333 DEXTER AVE. N.

SEATTLE, WA
DPD#: 3019618

DRB RECOMMENDATION MEETING
WEST DESIGN REVIEW BOARD

JANUARY 06, 2016

DESIGN RESPONSE TO DEXTER. AVE. STREETScape

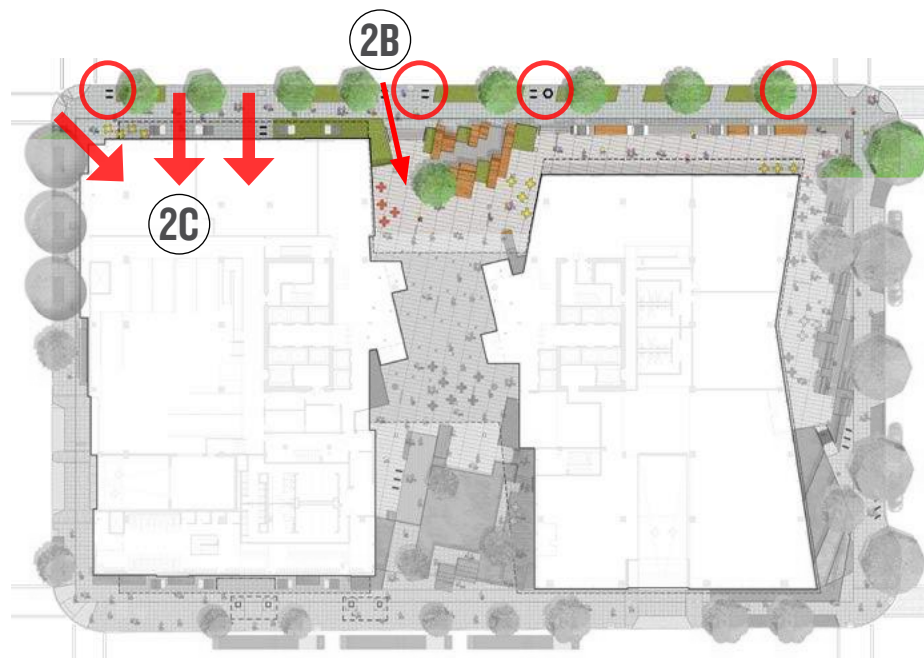
RESPONSE TO COMMENT 2B:

RESPONSE TO COMMENT 2C:

PROVIDED SHORT TERM BIKE PARKING, A PUMP STATION AND A BIKE RUNNEL INTEGRATED WITH THE STAIR INTO THE THROUGH BLOCK

RESOLVED RETAIL RELATIONSHIPS TO STRUCTURAL COLUMNS

DESIGN RESPONSE TO HARRISON. AVE. STREETScape

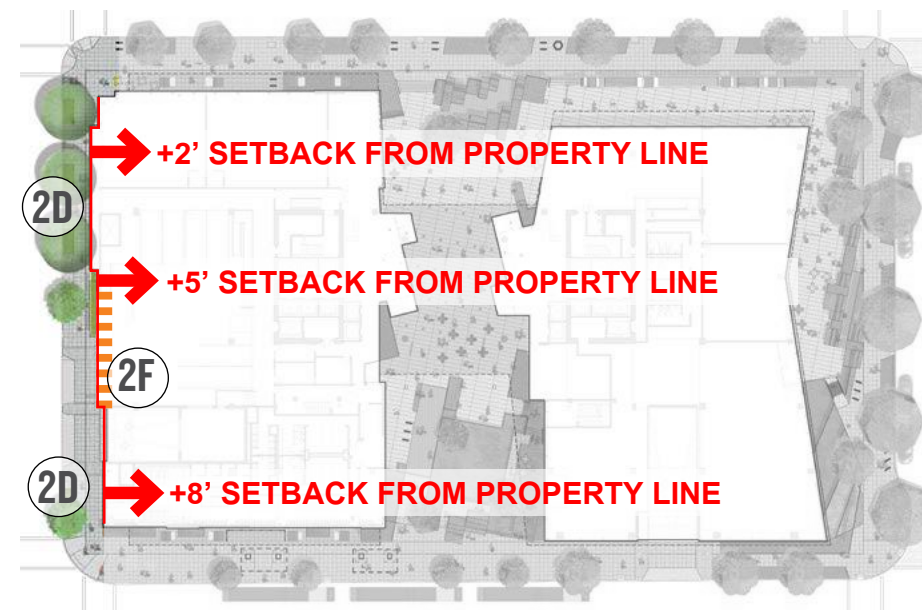
RESPONSE TO COMMENT 2D:

RESPONSE TO COMMENT 2F:

INCREASED SETBACKS ALONG HARRISON ST. TO PROVIDE SIDEWALKS THAT MEET GREEN STREET REQUIREMENTS

LOCAL ARTS ORGANIZATIONS WILL HOLD A STUDENT COMPETITION FOR THE ART WALL INSTALLATION TO MINIMIZE BLANK FACADE ALONG HARRISON ST.

OPEN SPACE & THROUGH BLOCK CONNECTION

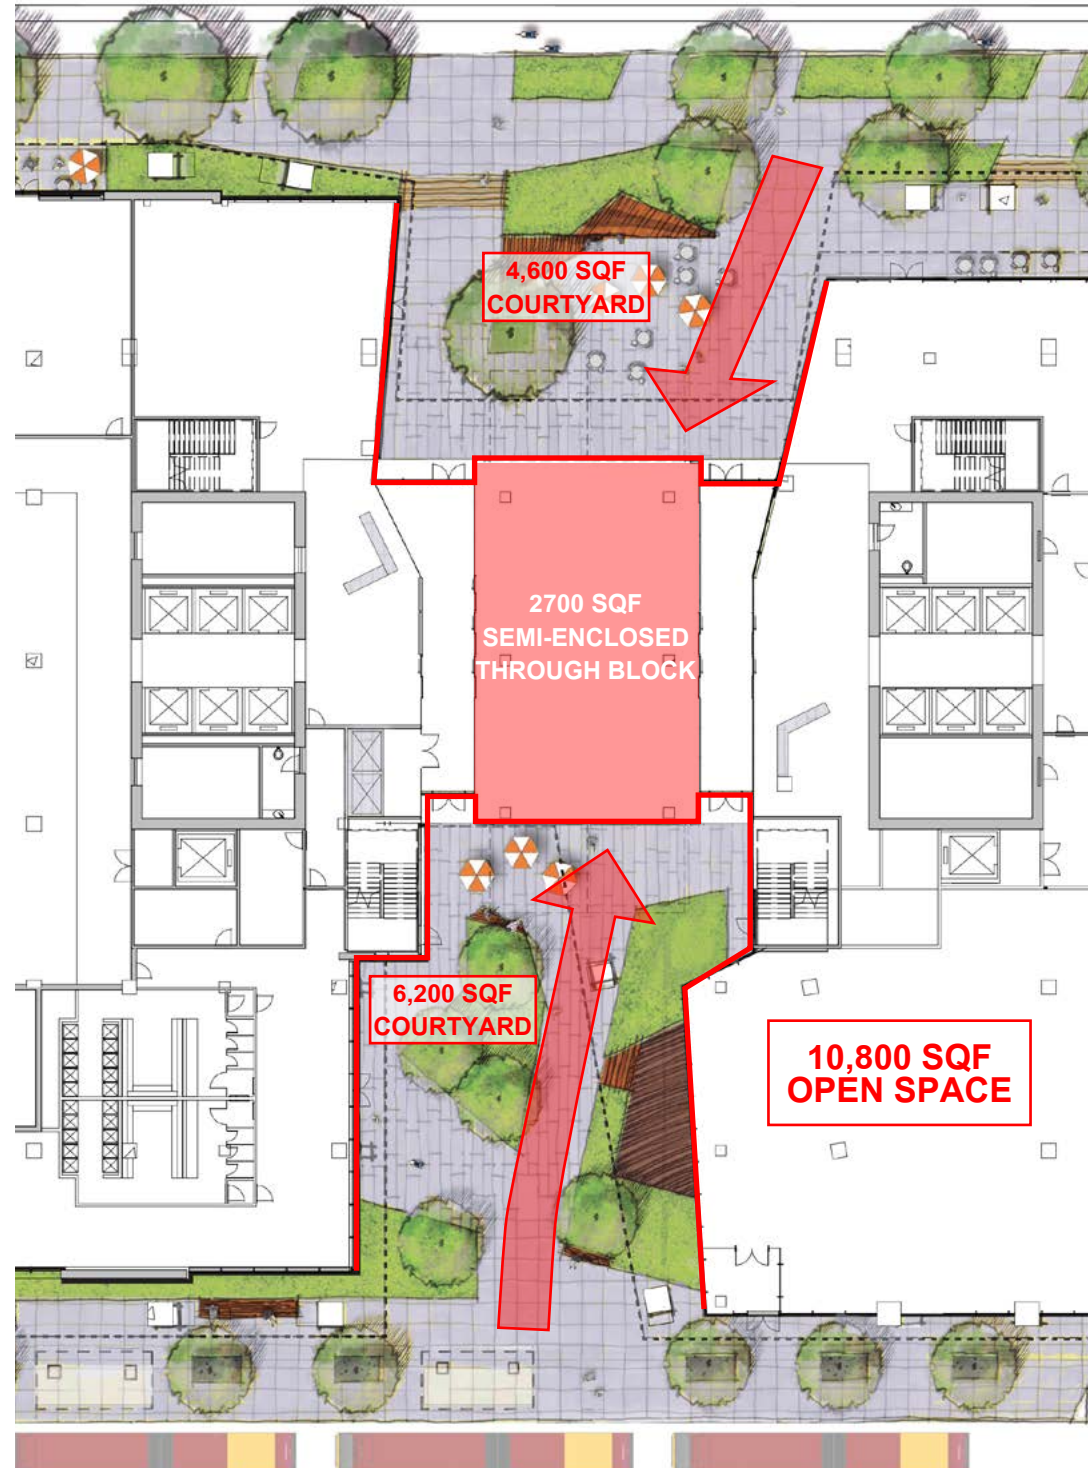
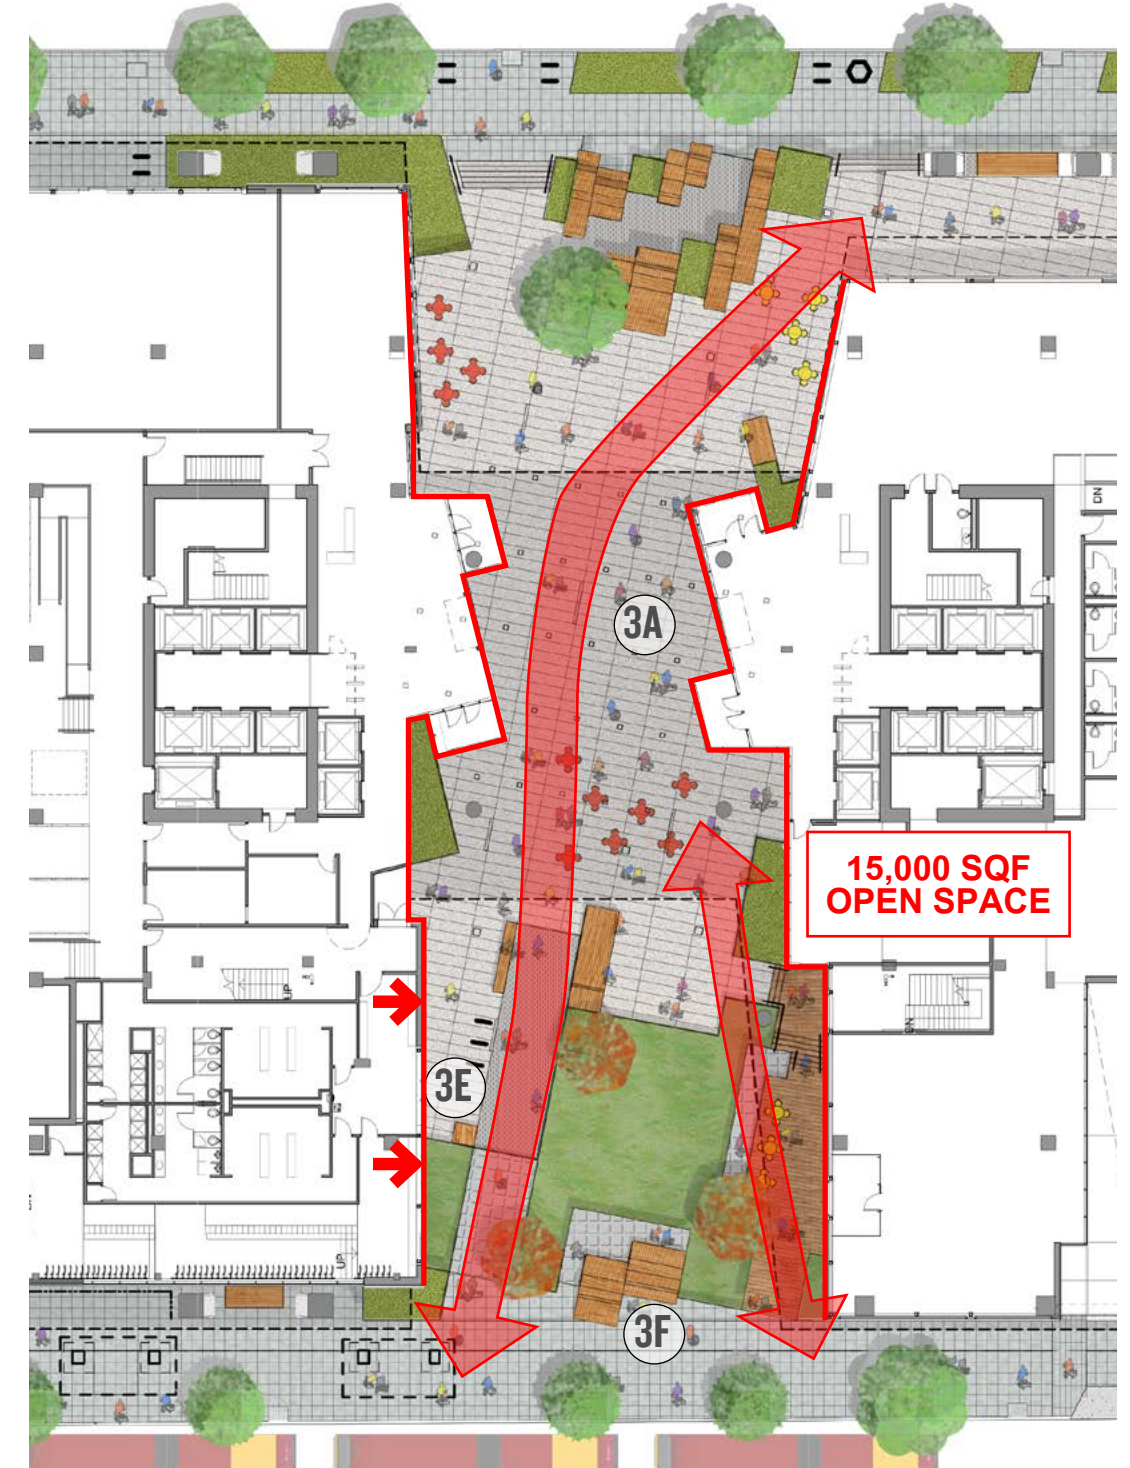
RESPONSE TO COMMENT 3A:
SEMI-ENCLOSED THROUGH BLOCK
OPENED UP TO PUBLIC ACCESS
24/7 TO CREATE SEAMLESS PUBLIC
REALM

RESPONSE TO COMMENT 3E:
IMPROVED THROUGH BLOCK
EXPERIENCE WHILE SHIFTING
THROUGH BLOCK SOUTH TO GIVE
MORE SETBACK ALONG HARRISON.

RESPONSE TO COMMENT 3F:
LANDSCAPING ALONG AURORA
REDUCED TO PROVIDE MORE OPEN
SPACE INTO THROUGH BLOCK AND
GIVE ADDITIONAL SEATING OPTIONS
FOR RAPIDRIDE STOP

DEXTER AVE. STREETScape

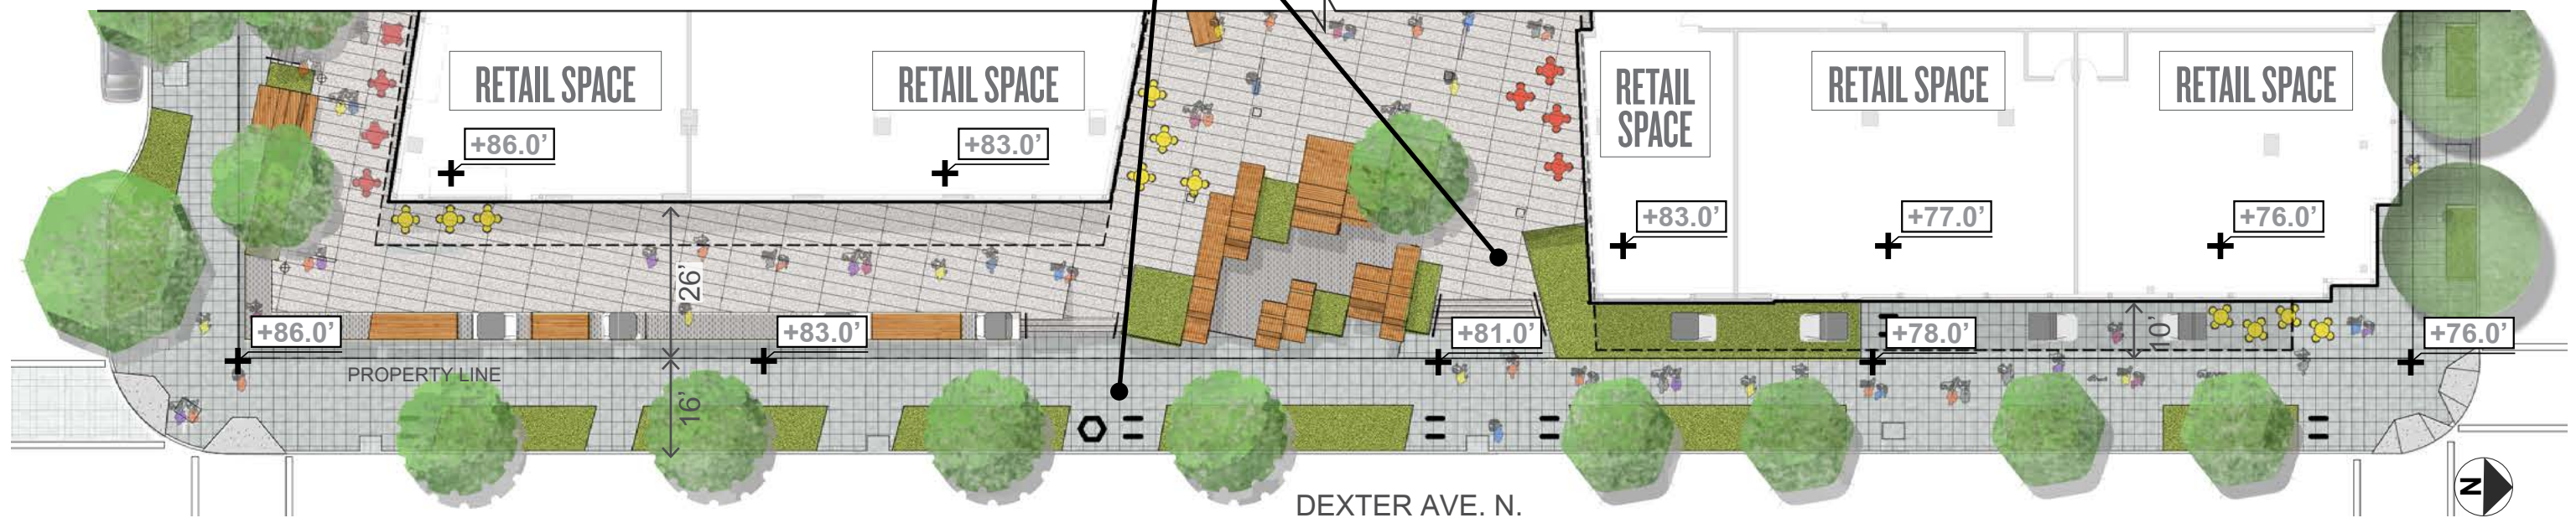
EDG2 COMMENT:
ITEM 2.A Maintained porosity of the site design

EDG2 COMMENT:
ITEM 2.B Providing a bike pump station and bike ramp up to open through-block

EDG2 COMMENT:
ITEM 3.A Through-Block connection opened up to provide continuous public realm

EDG2 COMMENT:
ITEM 2.C Resolved the relationship of the retail space entries and the structural columns at the north tower. (PL3.C.1)

HARRISON STREET STREETScape

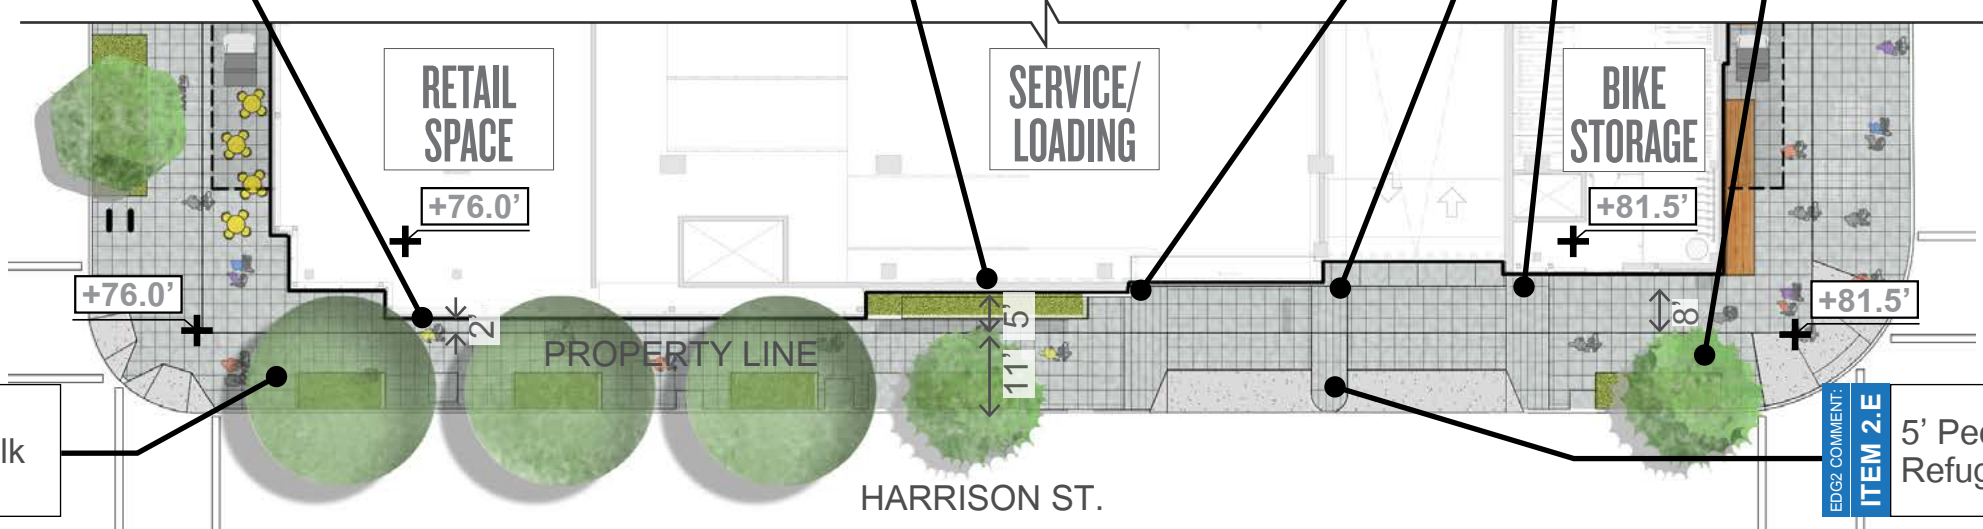
EDG2 COMMENT:
ITEM 2.D Setbacks along Dexter & Aurora shorten the building mass & allow for retail spill-out

EDG2 COMMENT:
ITEM 2.F Art Wall at Loading dock to be part of a design competition; see page 24-25 for more information

EDG2 COMMENT:
ITEM 2.E Signage & lighting give pedestrians visual cue of parking garage access

EDG2 COMMENT:
ITEM 2.E Sidewalk texture provides visual cues for pedestrians; see page 72 for more information

EDG2 COMMENT:
ITEM 2.D Increased storefront setback to 2' at the retail storefront to help activate Harrison St.

EDG2 COMMENT:
ITEM 2.D 5' setback allows for a 5' planting zone, 8' sidewalk and a 3' landscape buffer at Art Wall

EDG2 COMMENT:
ITEM 2.D 8' setback allows for improved open space experience that wrap the corner of the building

EDG2 COMMENT:
ITEM 2.D Sidewalk meets Green Street standards for sidewalk improvements

EDG2 COMMENT:
ITEM 2.E 5' Pedestrian Refuge Zone

AURORA AVENUE STREETScape

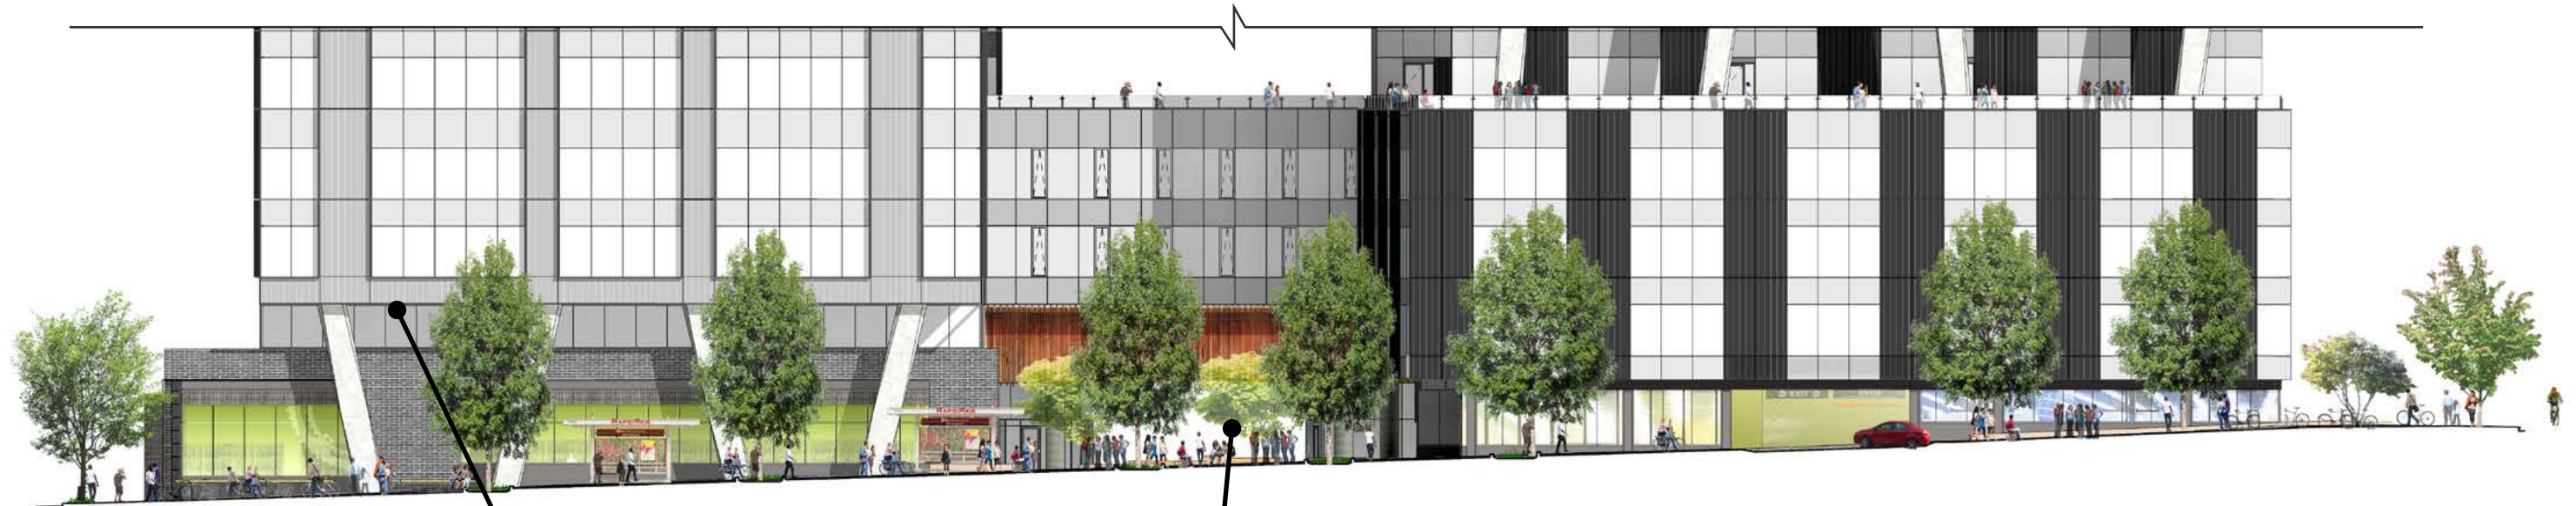
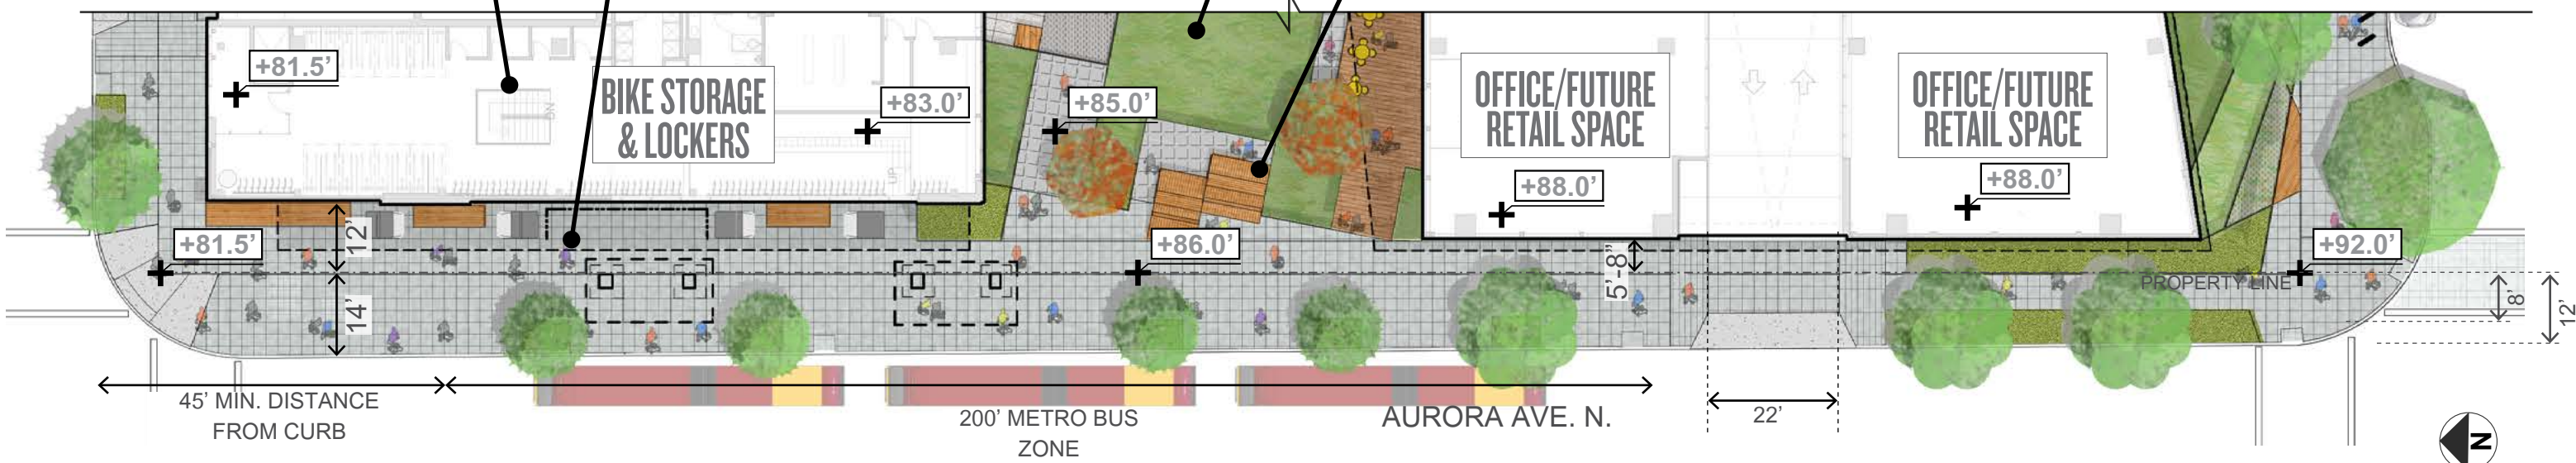
EDG2 COMMENT:
ITEM 3.A Through-block lobby removed and completely opened up to the public 24-7

EDG2 COMMENT:
ITEM 2.I Raingarden creates a backdrop for Metro bus stop & buffers building entry from street noise

EDG2 COMMENT:
ITEM 2.H Building overhang and (2) RapidRide shelters provide cover for people waiting for bus

EDG2 COMMENT:
ITEM 3.F Folded bench seating integrated with landscape
